# Backfeed in a 4-pair context

Dept: Ethernet Switch Product Field.

## IEEE\_P8023bt\_DRAFT\_3p4 145.3.8.8 Backfeed voltage

## 4-pair backfeed

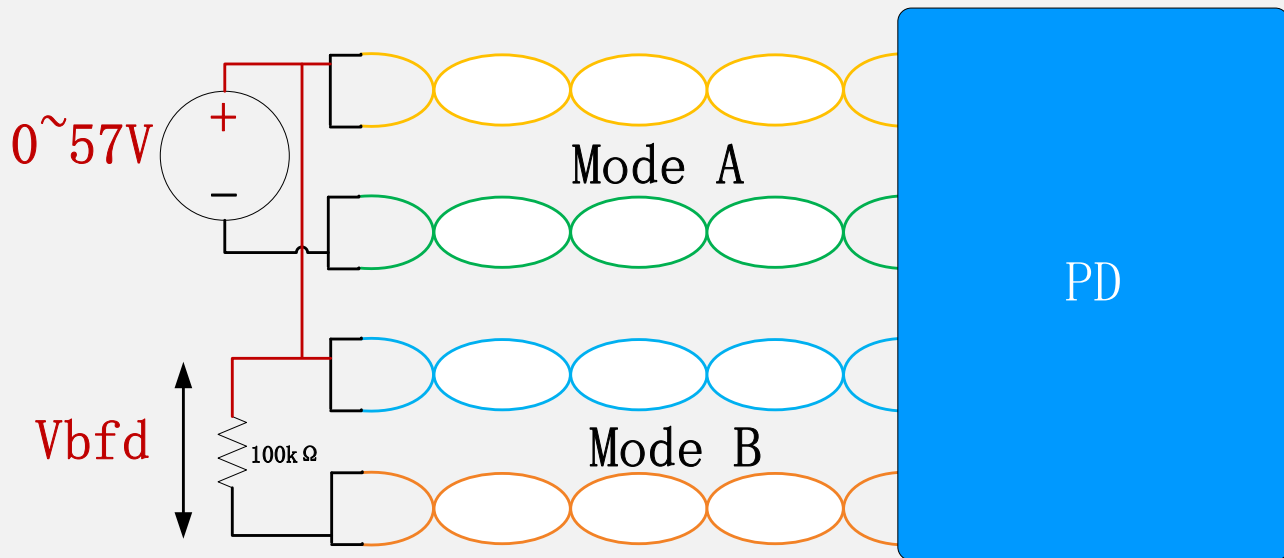
A 4-pair capable PSE typically ties the positive lines together at the PSE end. Even in “2-pair” mode, there are two pairs connected to the positive VPSE.

***Change 145.3.8.8 (backfeed\_d3baselinep4.pdf , version v212)as follows:***

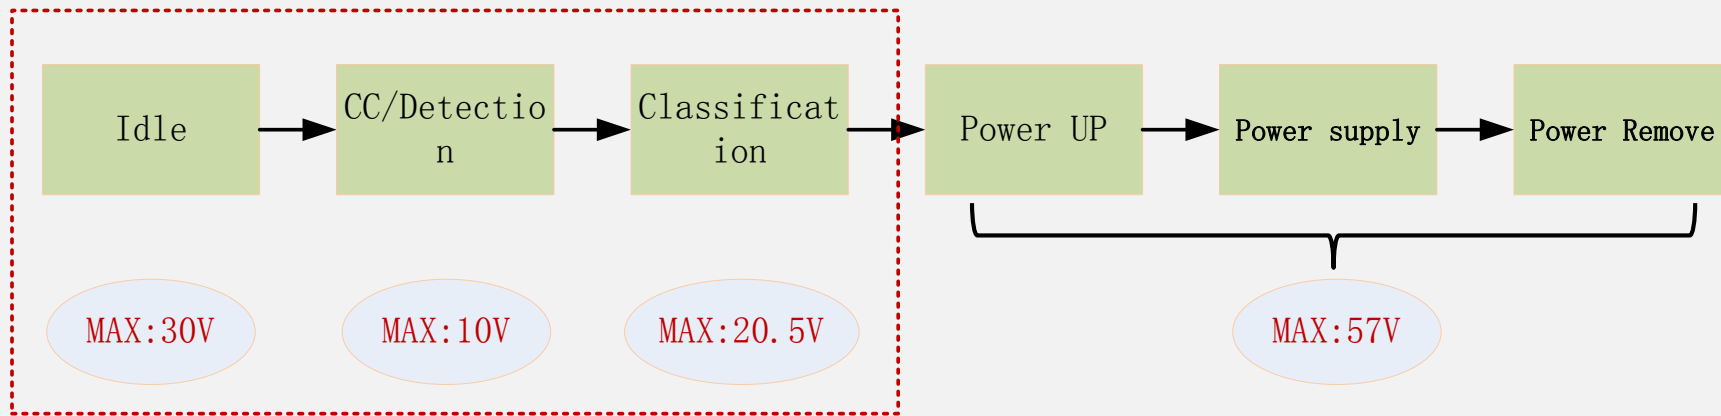
# The reason to change to 30V

Vrefl cannot affect processes before power up

For a single-signature PD, when any voltage in the range of 0V to VPort PD-2P max is applied per any of the valid 2-pair configurations, defined in Table 145–20, that have only a single pair connected to positive VPSE, the voltage on the Mode not connected to the voltage source, with a 100 kΩ resistor connected across that Mode, shall not exceed Vrefl as defined in Table 145–29.

For a single-signature PD, when any voltage in the range of 0V to ~~10.1V~~ 30V is applied per any of the valid 2-pair configurations, defined in Table 145–20, including those with two pairs connected to positive VPSE, the voltage on the Mode with at least one pair not connected to the voltage source, with a 100 kΩ resistor connected across that Mode, shall not exceed Vrefl as defined in Table 145–29.

For a dual-signature PD, when any voltage in the range of 0V to VPort PD-2P max is applied per any of the valid 2-pair configurations, defined in Table 145–20, including those with two pairs connected to positive VPSE, the voltage on the Mode with at least one pair not connected to the voltage source, with a 100 kΩ resistor connected across that Mode, shall not exceed Vrefl as defined in Table 145–29.
